工程指示 / 要求簡箋(E.I.)

工程指示編號：EI / 0023 / 19

工程名稱：觀塘裕民坊

工程項目：幕牆 廠用配件 (橫料玻璃位)(鋁角封口)

DWG NO. : J837-CW-6002 REV. : D

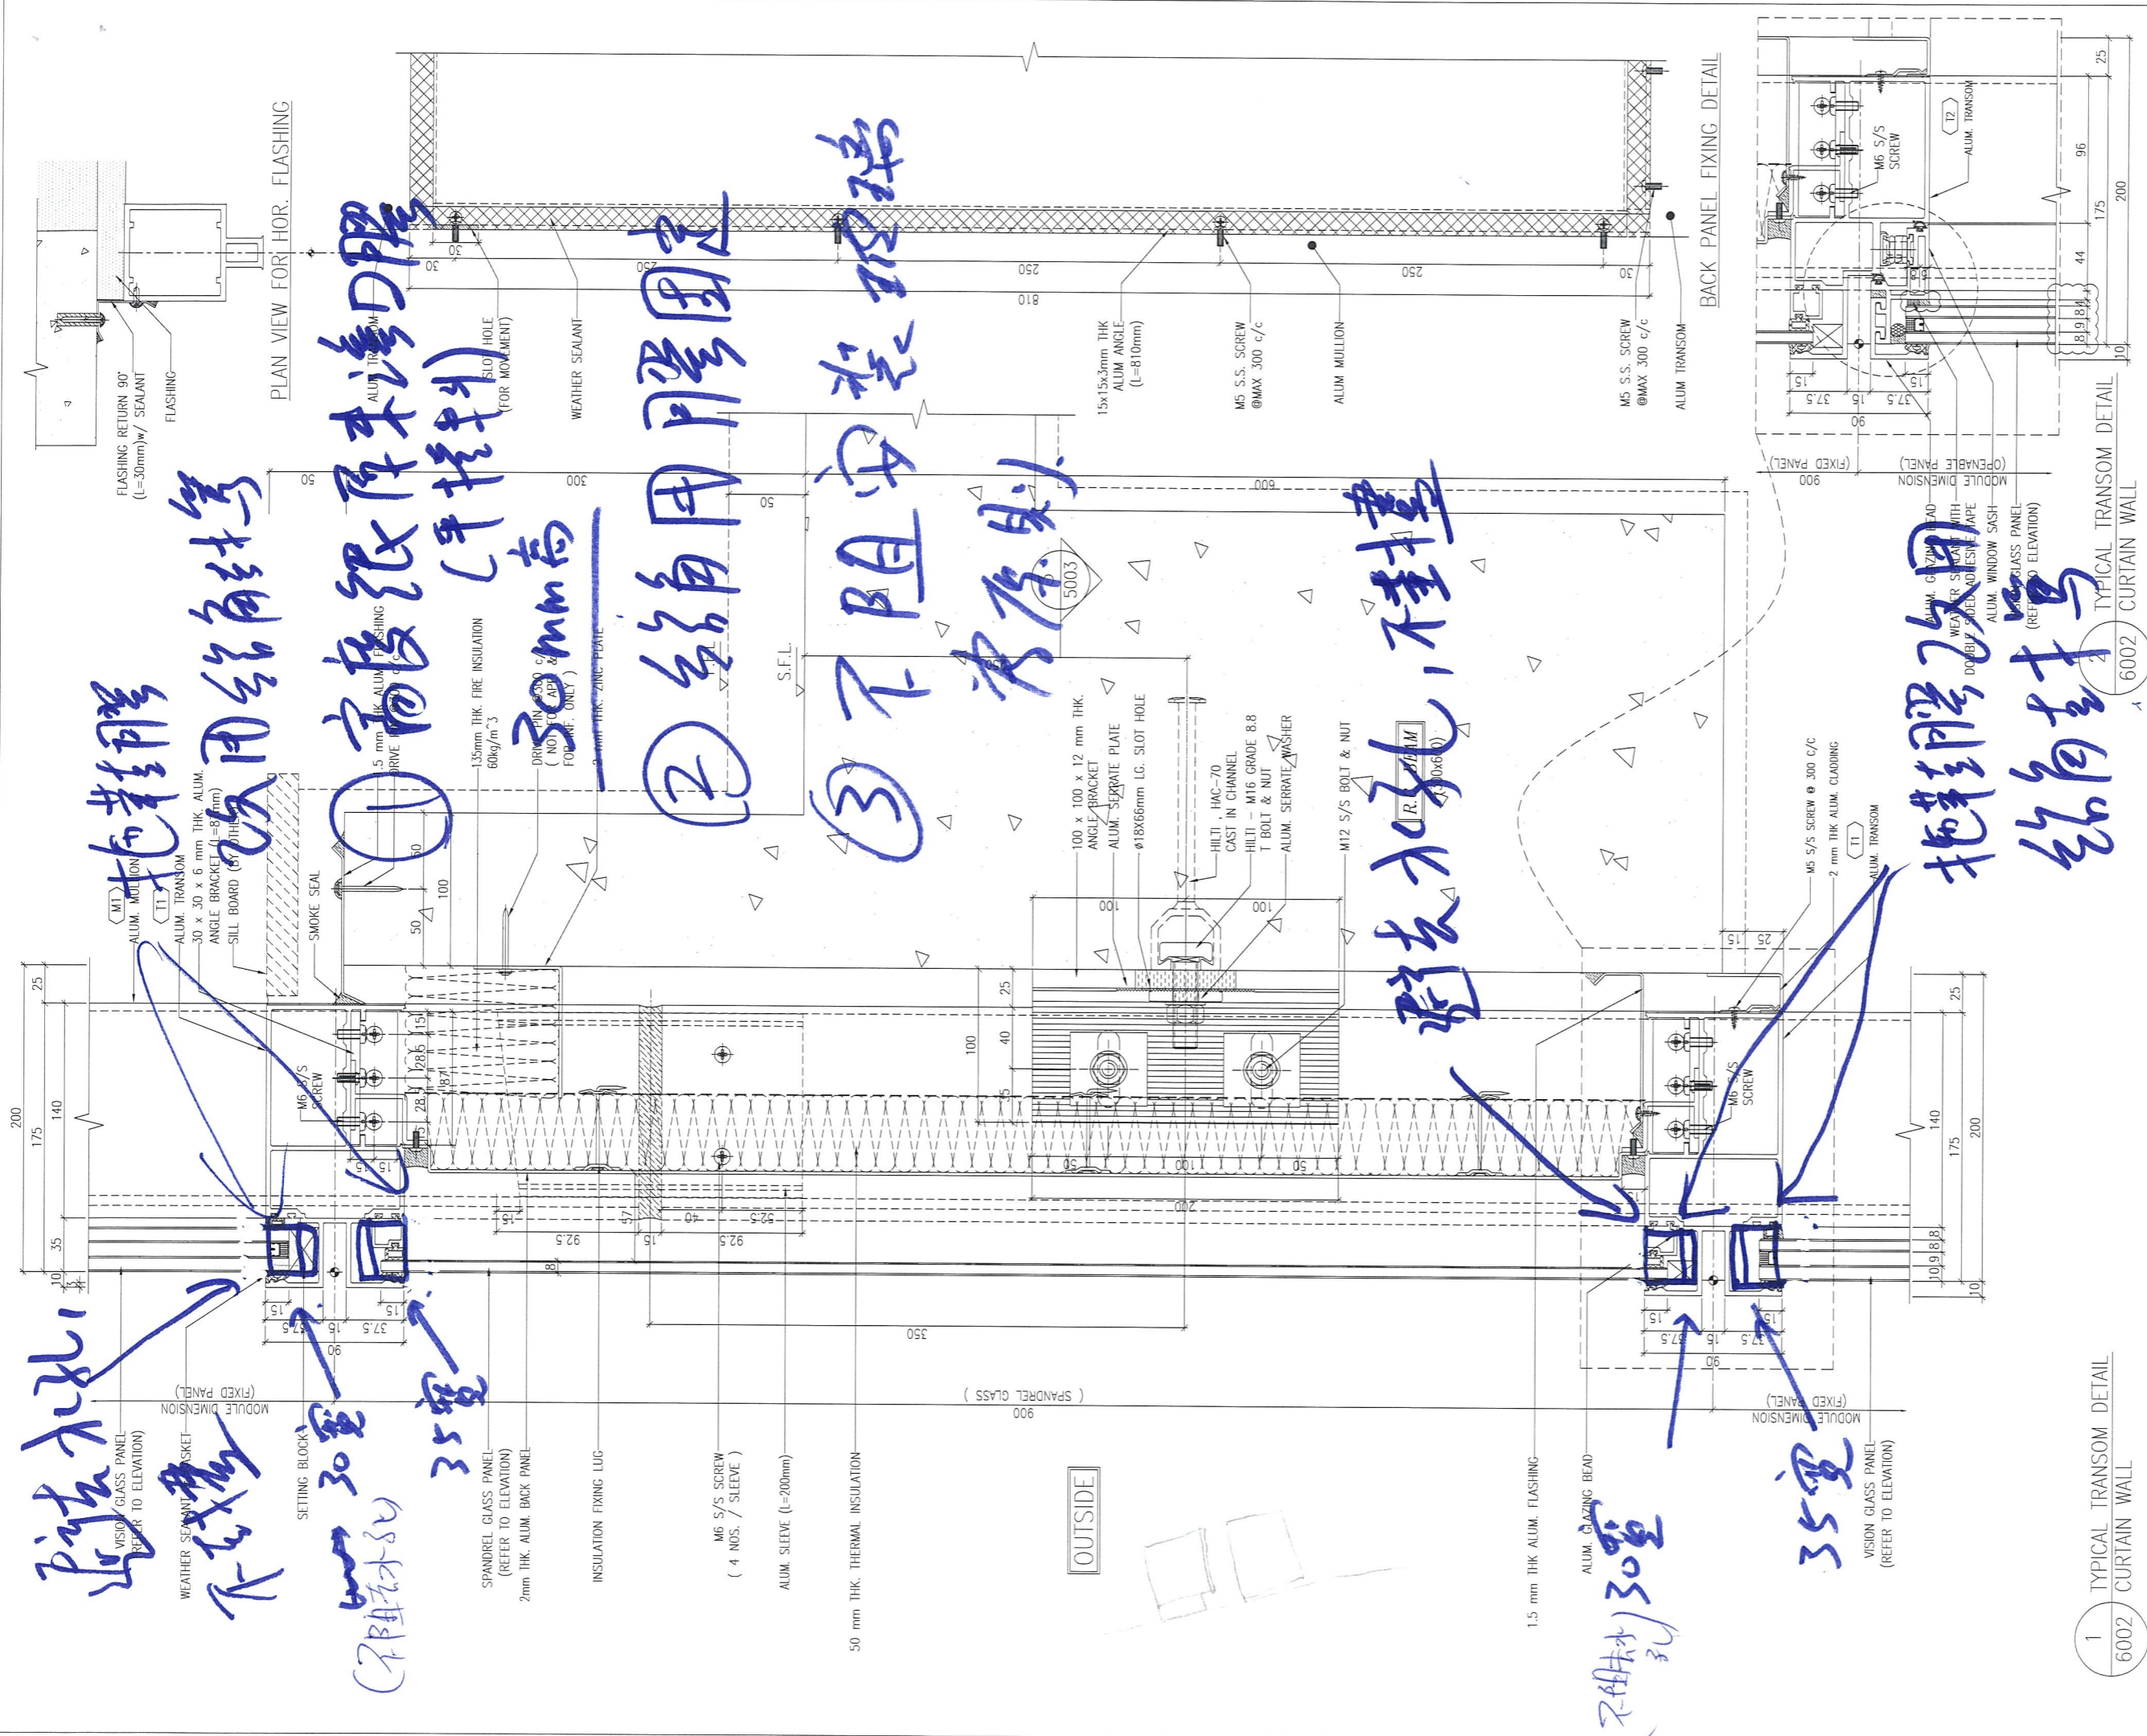
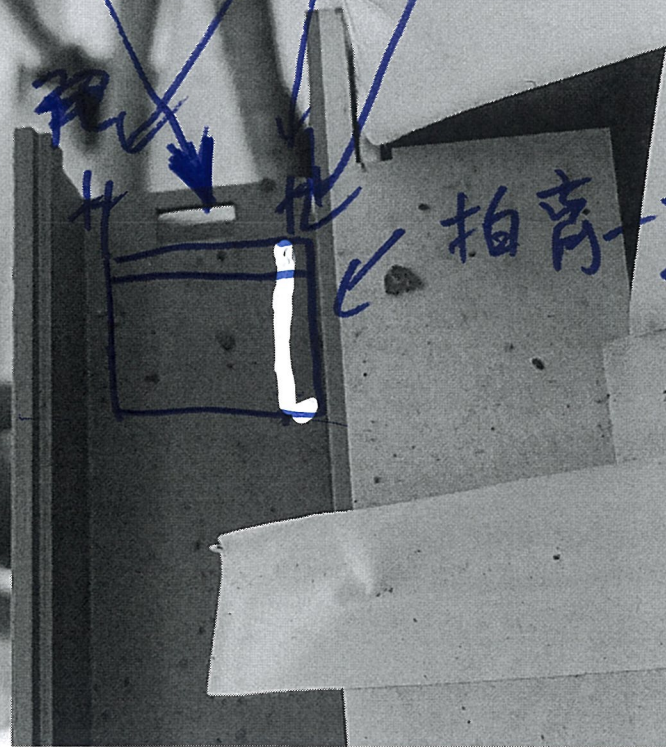
因應 EI10067 玻璃線及副框做法，橫料頂底(玻璃位置)會有個大吼

A 版: 1) 取消玻璃位置滲口膠，改用鋁角

3) 鋁角做法請參考後頁圖紙，永林請計算數量及提供加工圖

预留位置做水用 (5mm)

错角
避开去水孔
